SAFETY RELATED RECALL

Global Recall Action
Number: N759v4

Subject: Range Rover (L405) Front Suspension Knuckle Crack	Publication No.: N759v4
	Model: Range Rover (LG)
	Model Year: 2014 - 2016
	Date of Issue: 15 August 2025

E377524

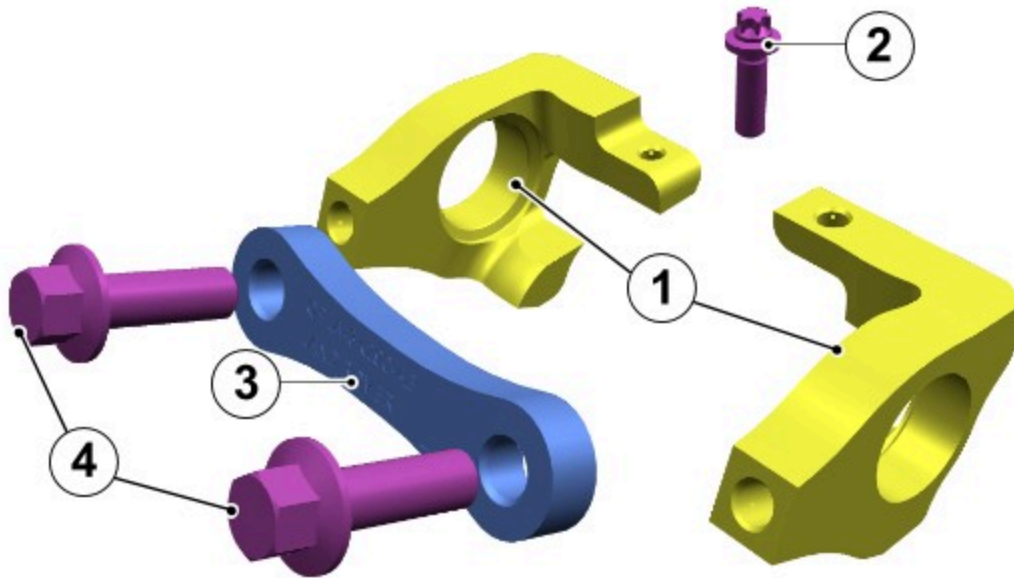
1. The illustration shows the front knuckle bracket components.

1. Front knuckle bracket side hooks.
2. Front knuckle bracket side hooks bolt.
3. Front knuckle bracket rear plate.
4. Front knuckle bracket rear plate bolts.

E332626

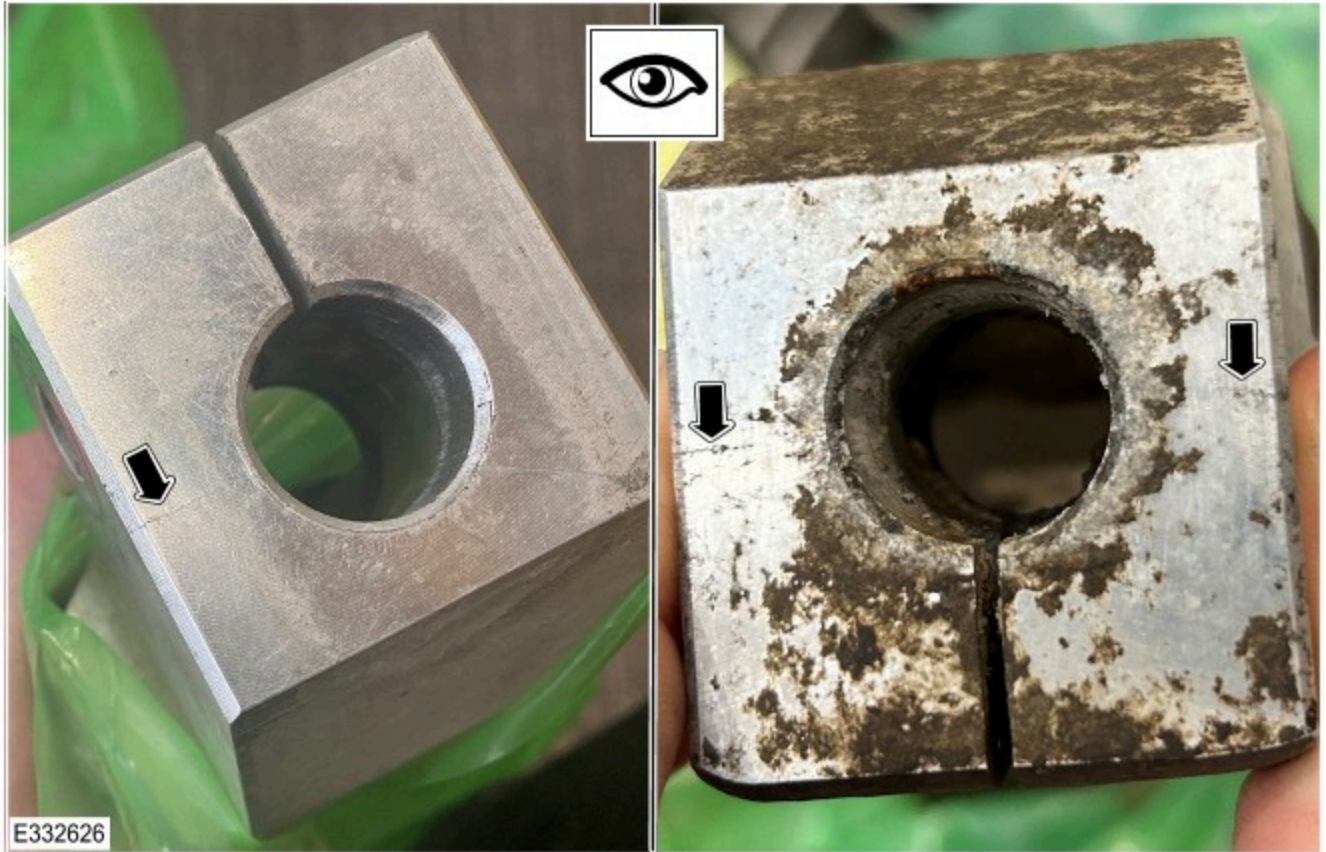
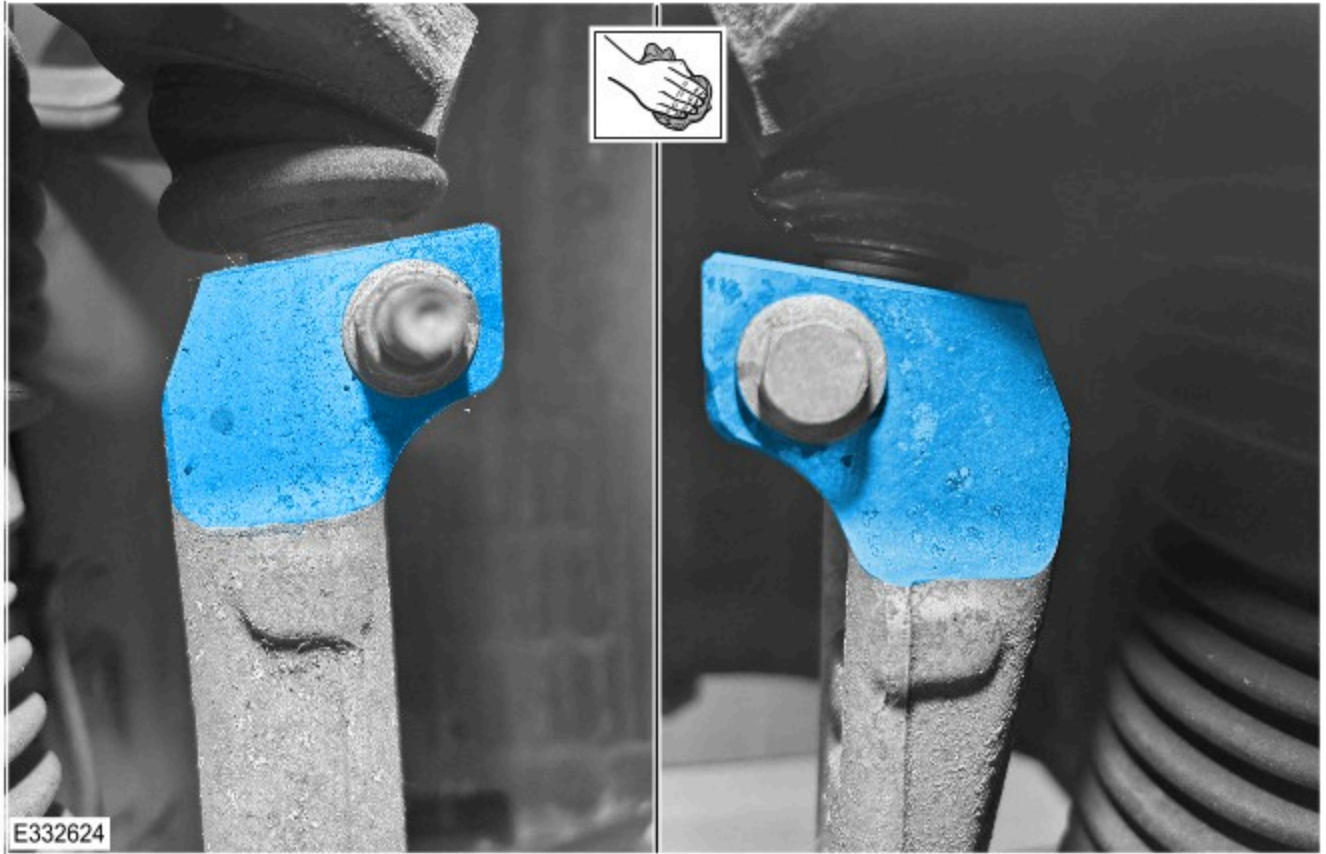
Examples of front knuckle cracks are shown in the illustrations.

- If cracks **ARE** visible on the front knuckle, the front knuckle has **FAILED** the inspection. Replace the front knuckle that has **FAILED** the inspection (see TOPIx Workshop Manual section 204-01: Front Suspension - Removal and Installation - Wheel Knuckle).
- If cracks **ARE NOT** visible on the front knuckle, the knuckle has **PASSED** the inspection. **Continue to the FRONT KNUCKLE BRACKET INSTALLATION PROCEDURE.**

E373427

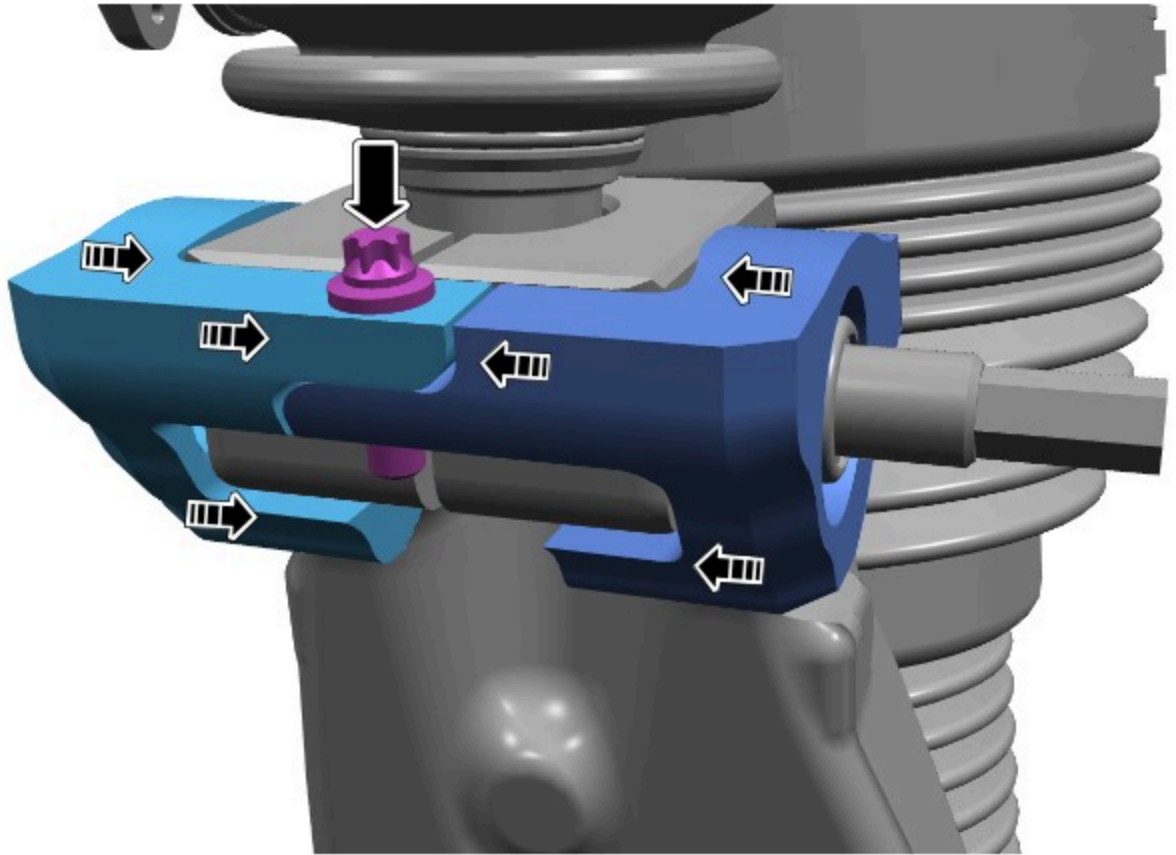
2. Install the 2 front knuckle bracket side hooks.

- Apply Loctite® 243 to the bolt.
- Install the bolt, finger tight only at this stage.

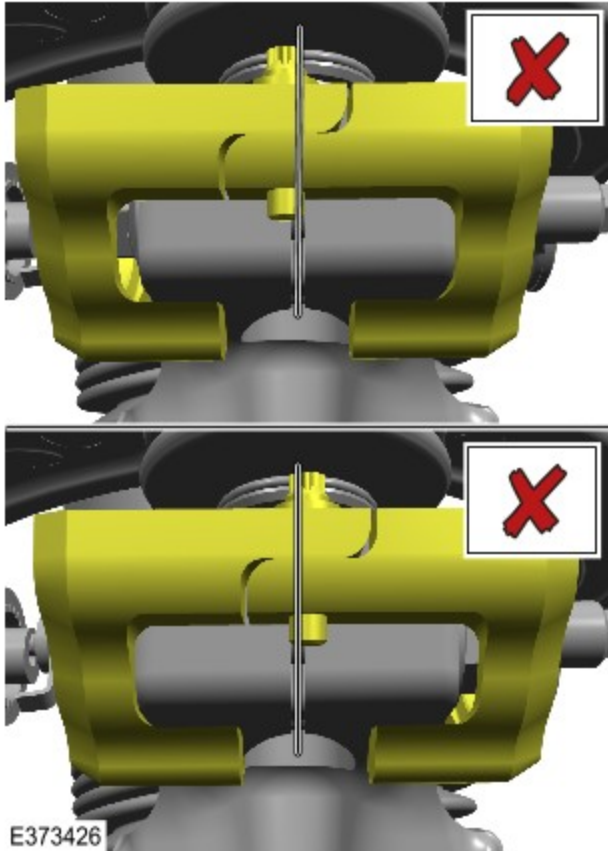
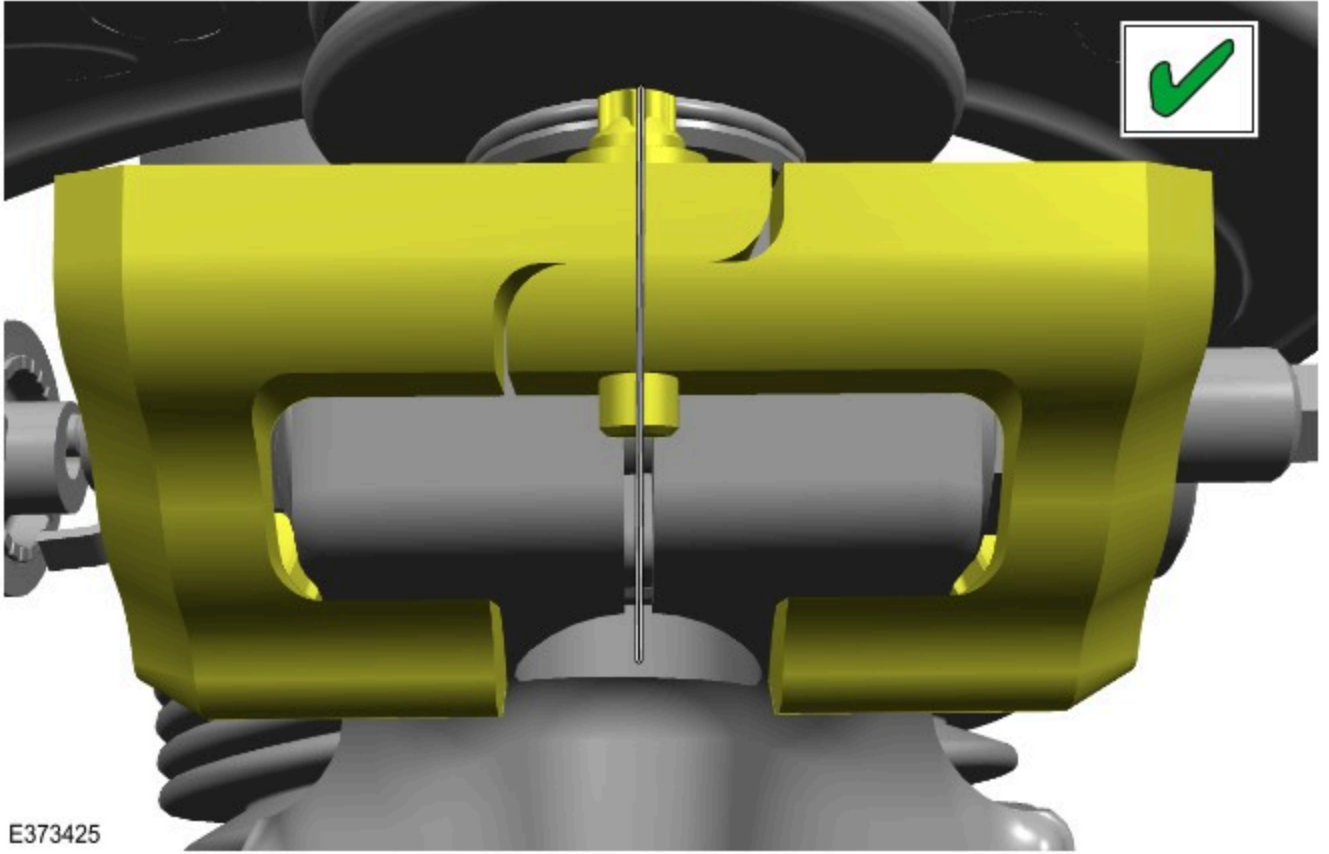
4. Align the front knuckle bracket to be central to the front knuckle.

- The front knuckle bracket must be centrally aligned to the front wheel knuckle as shown in the illustration with the **GREEN** ✓.
- The front knuckle bracket must not be aligned to the front wheel knuckle as shown in the illustrations with the **RED X**.

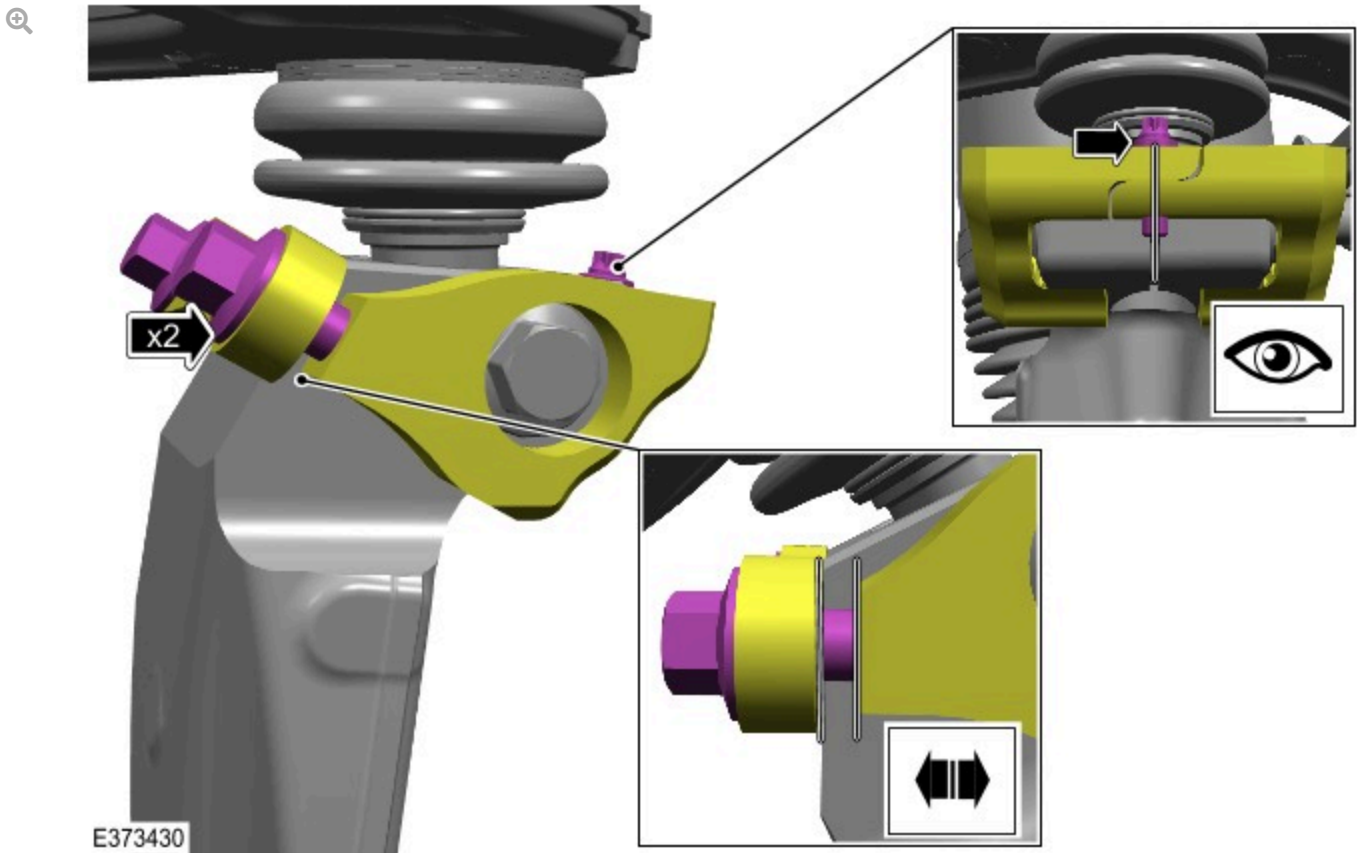
- There must be a gap between the front knuckle bracket rear plate and the 2 front knuckle bracket side hooks.
- The gap between the front knuckle bracket rear plate and the 2 front knuckle bracket side hooks must be maintained both sides of the front knuckle bracket rear plate.
- The front knuckle bracket must remain central to the front knuckle during tightening, as shown in the illustration.

Fully tighten the 3 front knuckle bracket bolts.

1. M5 Bolt: **6 Nm**
2. M8 Bolts:
 - Stage 1: **10 Nm**
 - Stage 2: **24 Nm**
